Cracking/Clicking Noise from Underbody

Topic number	LI61.20-P-077105
Version	1
Function group	61.20 - Lower engine compartment paneling
Date	11/14/23
Validity	All vehicles of model series 232 and 192.
Reason for change	Another video attached

Attachments	
File	Description
Schraubreihenfolge.jpg	Screw Sequence

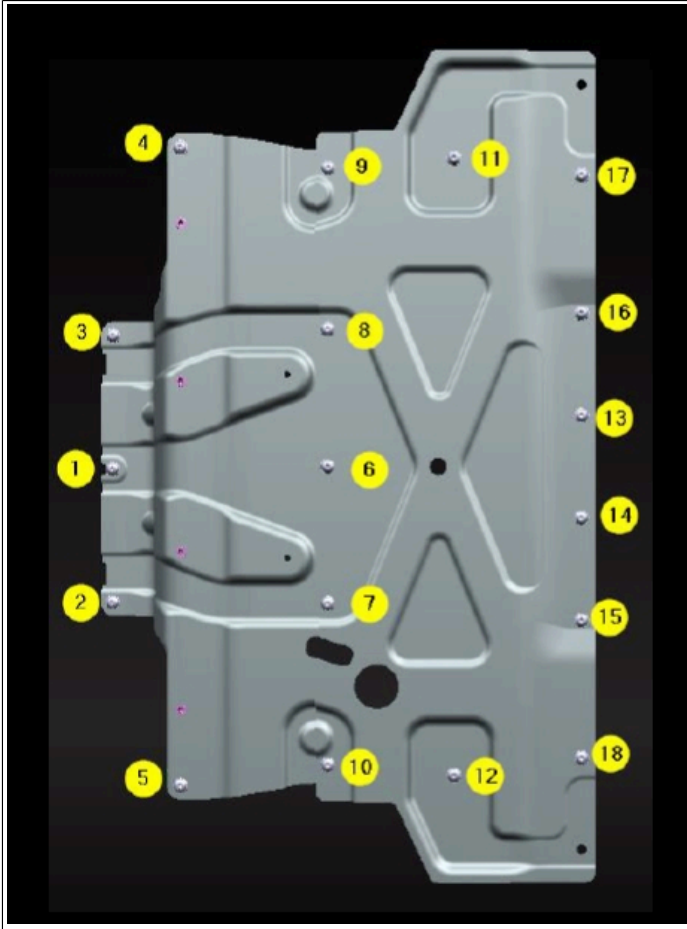
Tension in the lower engine compartment lining at the factory, with additional weight of vehicle body after complete build of the vehicle.

Implement screw connection of the shear area/the lower engine compartment lining (vehicle compressed) with 14 Nm and taking into account the correct screw sequence (see attachment).
